Planning Commission Staff Report

Item 6. a.

- SUBJECT:** PUD-99
- APPLICANT:** Pamela Hardy, Ponderosa Homes II, Inc.
- PROPERTY OWNERS:** John G. and Jana C. Altieri, et al.
- PURPOSE:** Application for Planned Unit Development (PUD) Development Plan to construct 19 single-family residences and related site improvements

- LOCATION:** 1851 Rose Avenue
- EXHIBITS:**
- A. [Recommended Conditions of Approval](#)
 - B. [Proposed PUD Development Plan, Tree Report, Updated Geotechnical study, Investigation of Potential Waters of the United States, Noise Assessment, Golf Ball Net Study, Visual Simulations](#), and [GreenBuilding Checklist](#)

Figure 2: Phasing Plan

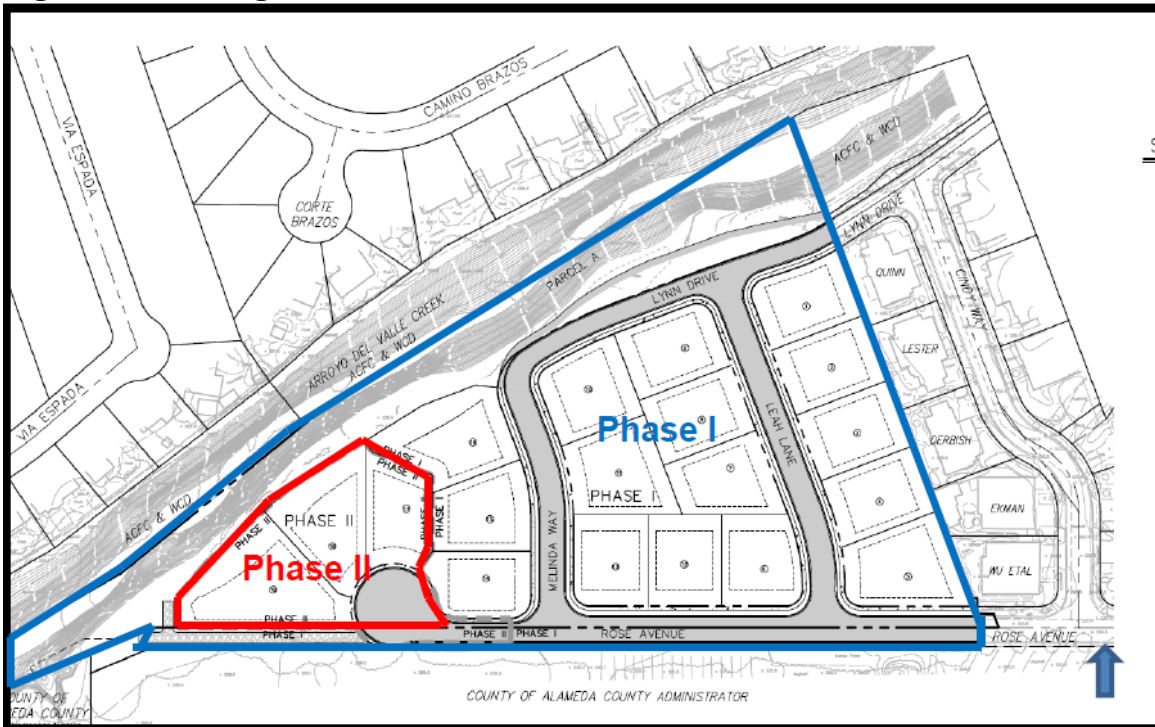
The existing driving range at the Alameda County Fairgrounds is located to the south of the project site. Golf balls have been exiting the fairgrounds and landing in the western portion of the project site. The applicant proposes to construct this 19-lot development in two phases. Phase I development would start if the project is approved. Phase II development would not occur until the driving range ceases operation. Figure 2 shows the proposed phased development.

Figure 4: Golf Ball Fence/Net Structure and Screen Tree Locations

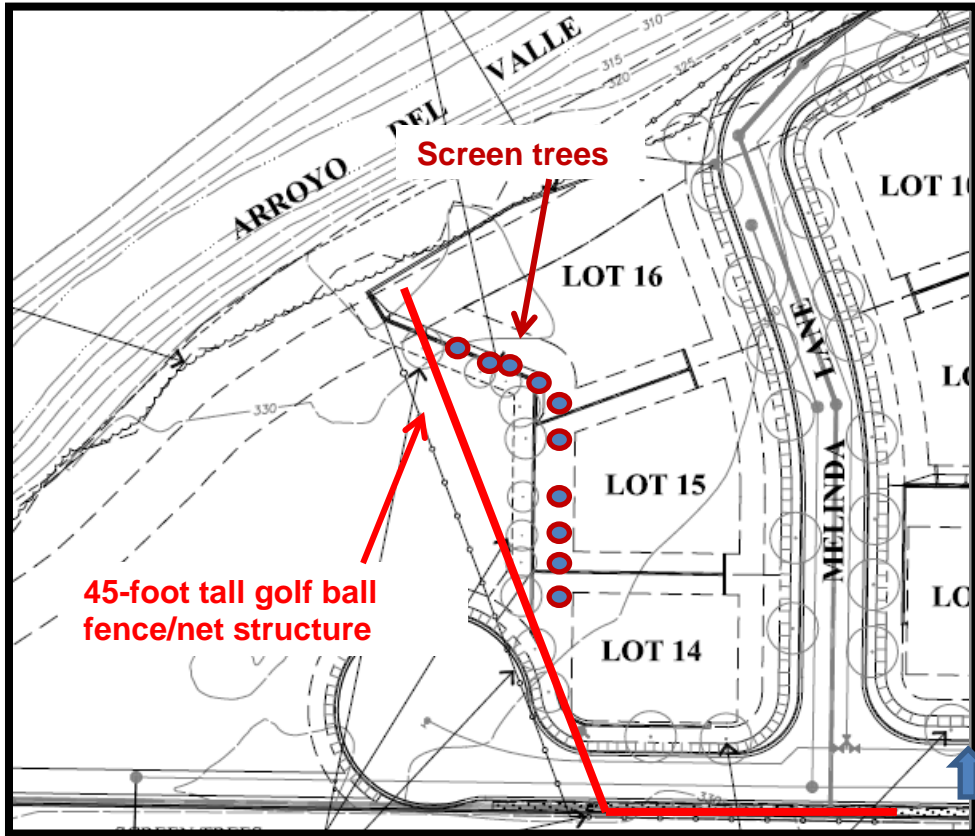
The project site is approximately 390 feet from the tees at the driving range and golf balls have been landing on the western portion of the project site. To protect the proposed residential development from being hit by golf balls from the driving range, a fence/net structure to block the balls would need to be erected. A golf ball trajectory study was prepared by Tanner Consulting Group (TCG), attached as Exhibit B. TCG completed a statistical study of golf ball trajectories at the current tee location as well as at the range landing area. The study includes four golf ball fence/net structure design options with golf ball fence/net heights at 135 feet (Options 1 and 2), 45 feet (Option 3), and 80 feet (Option 4) based on the net location.

Option 3 is proposed by the applicant (and is the option supported by staff) because it would be the least visually-obtrusive option. Option 3 entails delaying construction of Lots 17-19 and constructing a 45-foot tall golf ball fence/net structure behind Lots 14-16. The construction of Lots 17-19 would be delayed until the operation of the driving range at the fairgrounds ceases in approximately 18 years. To mitigate the visual impacts of the net, the applicant proposes to install screen trees near the rear property lines of Lots 14-16 (on future Lot 17) with a minimum size of 15 gallons. The golf ball fence/net structure will be constructed by the applicant and maintained by the applicant and its agent. The screen trees will be planted by the applicant and maintained by the HOA until Lots 17-19 are constructed. When the operation of the driving range ceases, the applicant or future developer will remove the fence/net structure. As the planted screen trees would be located on Lot 17, the owner(s) of Lot 17 could decide either to retain or remove the screen trees subject to the heritage tree requirement, if applicable. The development's HOA would no longer be responsible for the maintenance of these trees. Figure 4 shows the locations of the golf ball fence/net structure (Option 3) and screen trees.

Visual simulations from three viewpoints were prepared to assess the visibility of the netting. The visuals were prepared with the screen trees. The visuals show that the netting could be seen from areas on the north side of the arroyo, from Rose Avenue, and remotely from Valley Avenue. The appearance of the netting would be similar to that of the existing netting at the City's Callippe Preserve Golf Course. The visual simulations are attached in Exhibit B.
